PROJECT: COLLEGE OF THE REDWOODS MENDOCINO RESIDENCE HALL RE-ROOF
Redwoods Community College District
NMR Project No. 10-2529

GENERAL: This **Addendum Number Two** shall be inserted into your set of Drawings and Specifications for this project and shall take precedence over the original Drawings and Specifications. Acknowledge receipt of this Addendum in the space provided on the Bid Form. Failure to do so may subject the Bidder to disqualification.

ADDENDUM TWO (Rev. A1.1)
RESIDENCE HALL 'MENDOCINO' REROOF
COLLEGE OF THE REDWOODS - EUREKA CAMPUS

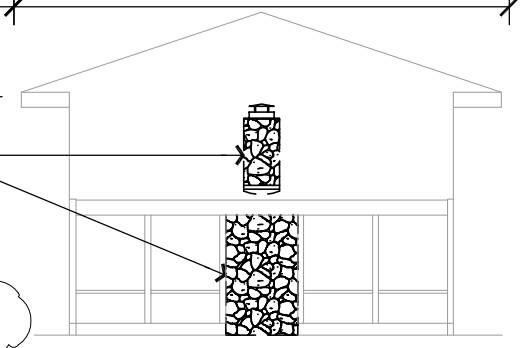
- D1.02 Refer to Drawing Exhibit A1.1, and **attached new Sheet AD2/A1.1**: Refer to additions, clarification, and adjustments made under Delta ADD2. Revisions include: Clarification of existing rain water leader locations; The addition of the lower porch roof; Investigation of the eave along the south end of the building; Inclusion of second residence hall to ADD-ALTERNATE 1; Text revisions in DEMO notes.

ADDENDUM TWO (Rev. A1.2)
RESIDENCE HALL 'MENDOCINO' REROOF
COLLEGE OF THE REDWOODS - EUREKA CAMPUS

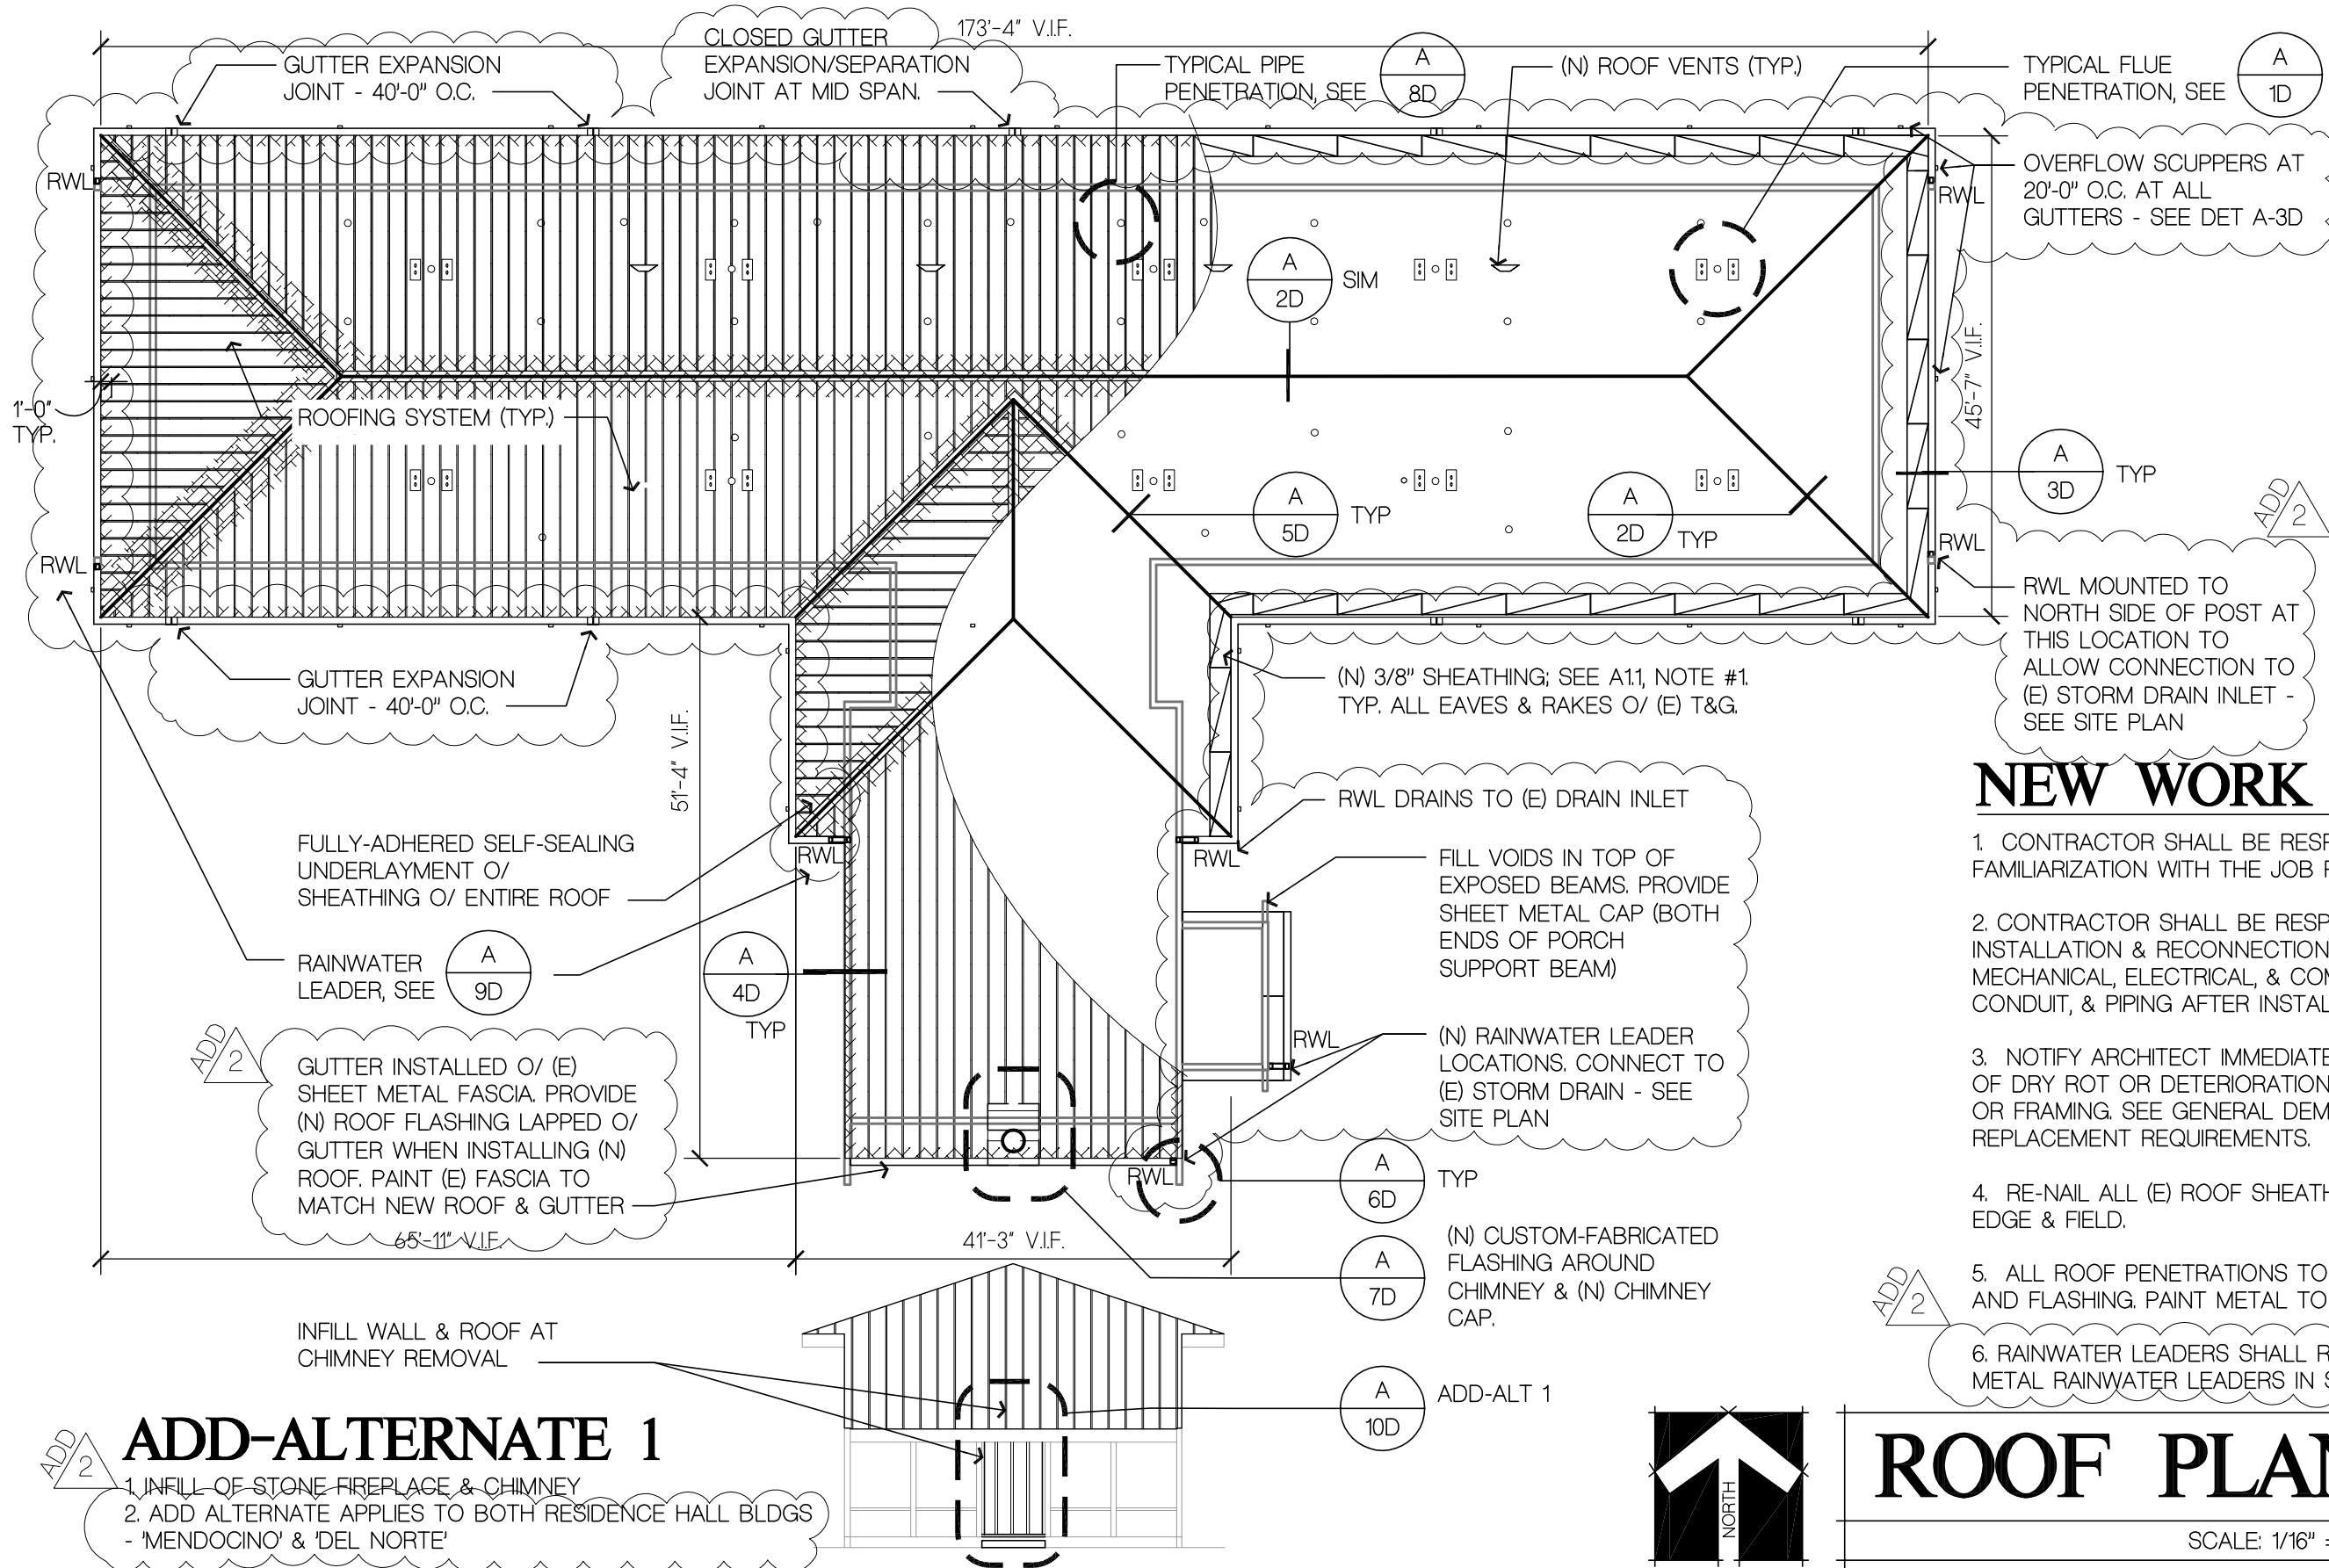
- D1.03 Refer to Drawing Exhibit A1.2, and **attached new Sheet AD2/A1.2**: Refer to additions, clarification, and adjustments made under Delta ADD2. Revisions include: Clarification of number of rain water leaders required and locations; Addition of gutter expansion joints; Addition of overflow scuppers to gutters; Clarify gutter installation over existing metal fascia at south end of building; Repair beam tops and add sheet metal caps over existing beam ends at lower porch; Inclusion of second residence hall to ADD-ALTERNATE 1.

ADD2 - ROOF TO WALL

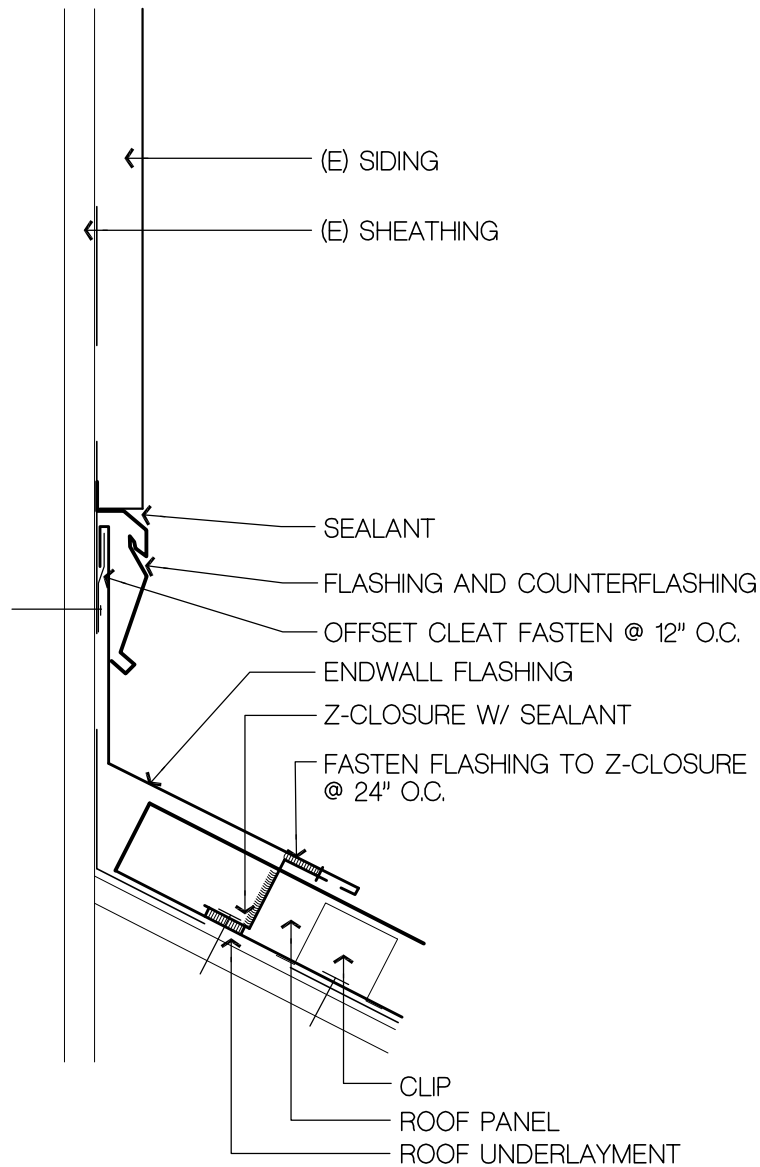
- D1.06 Refer to Drawing Exhibit A-11D, and **attached new Sheet AD2/11D**: New Detail added to project for roof to wall detail at lower porch roof.
